October 3, 2022

TCMC EMERGENCY DEPARTMENT

POST-BID ADDENDUM NO. 4

SHEET NUMBER:
E204

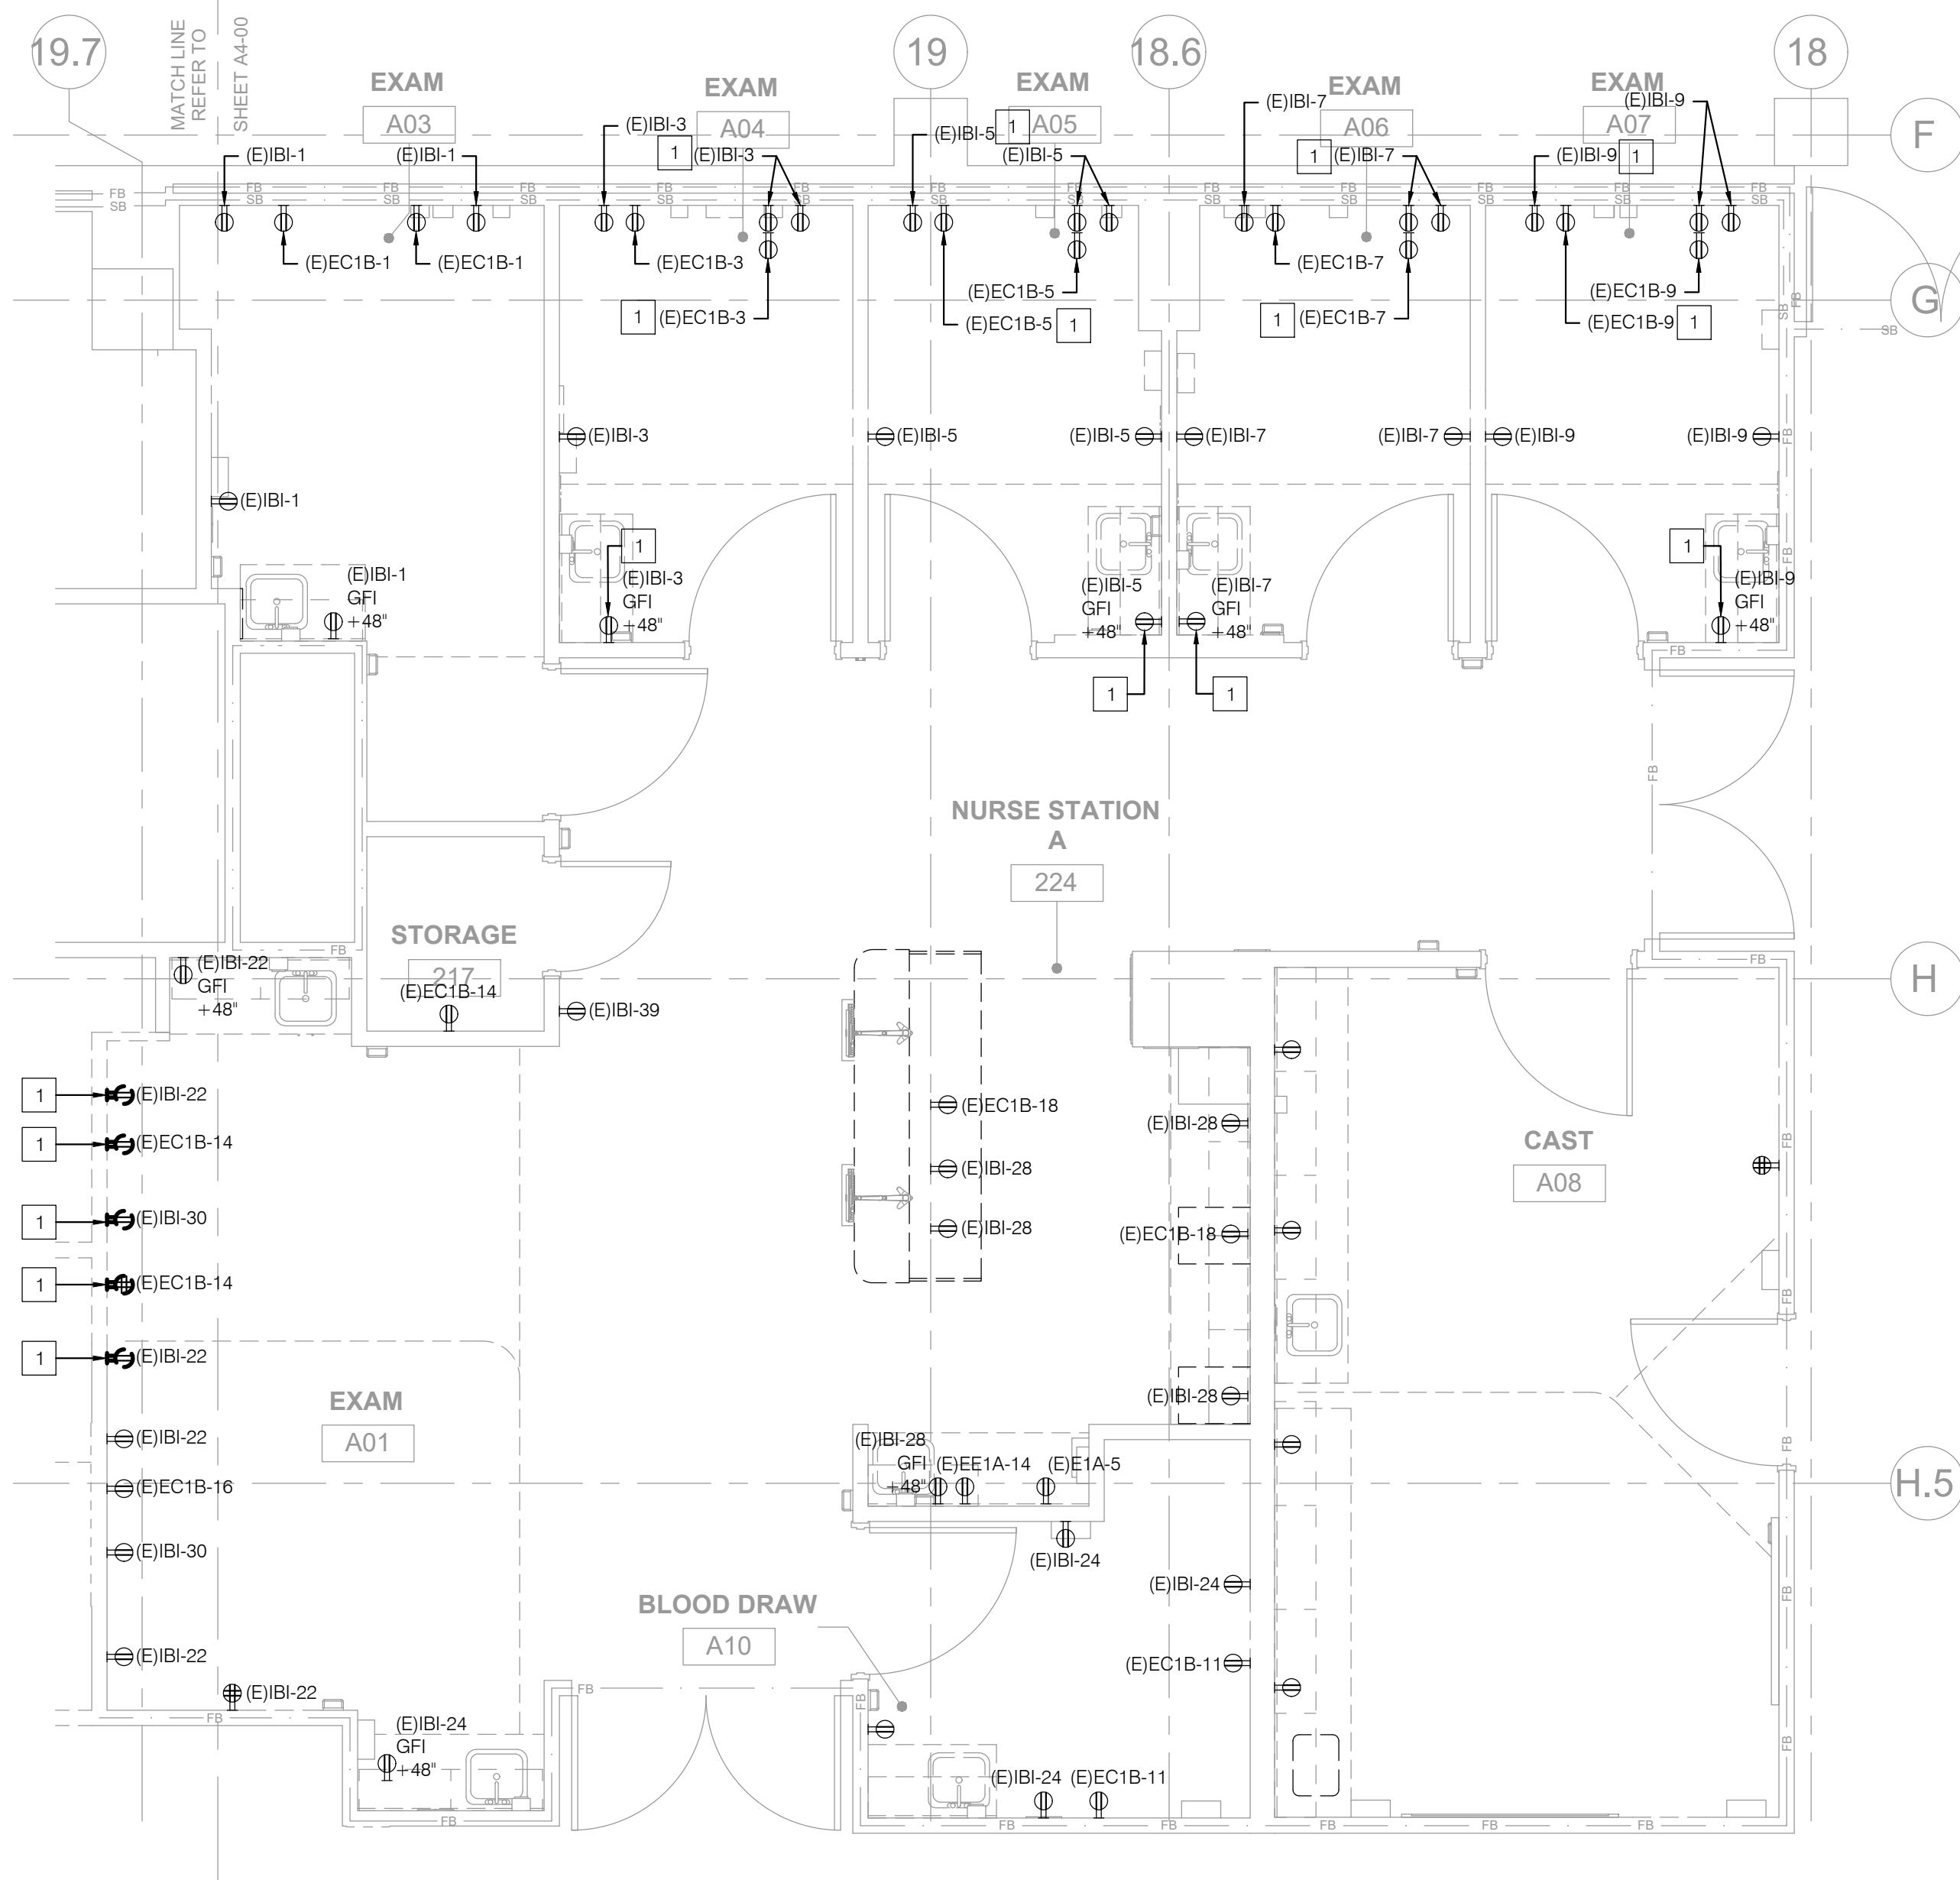
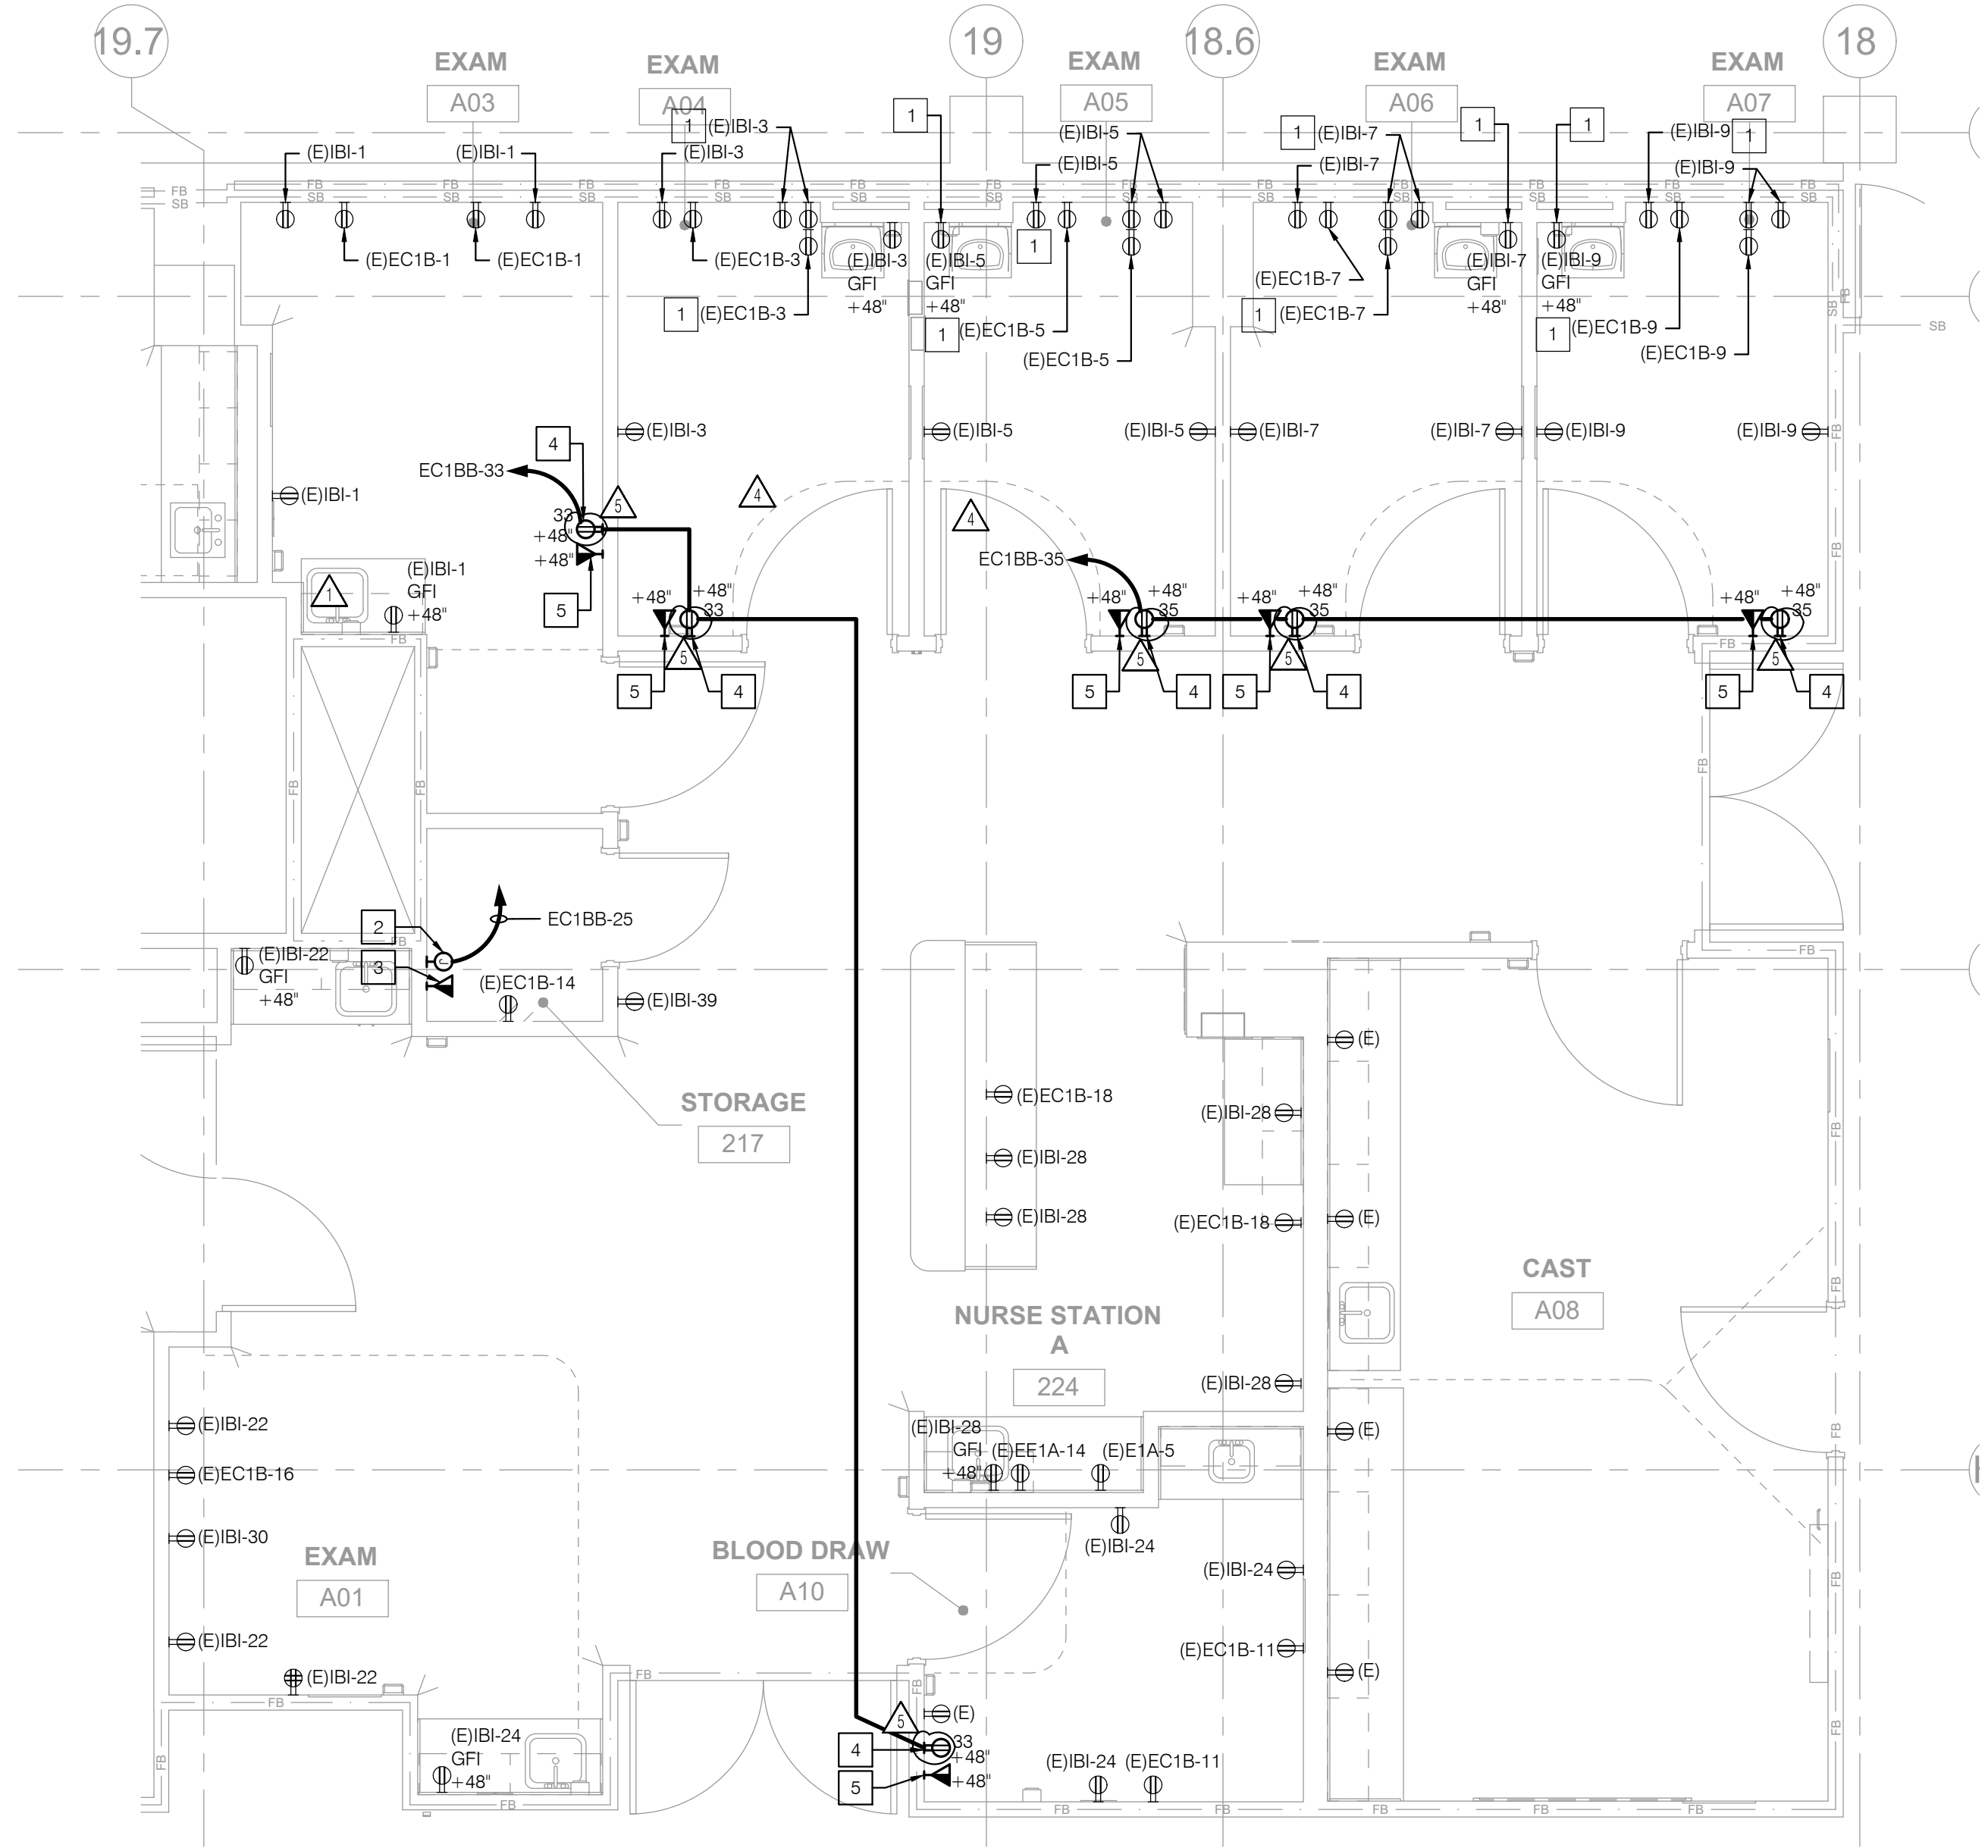
See attached revised drawings with delta 5 dated 9/23/22:
E201, E204, E206, T001, P002.
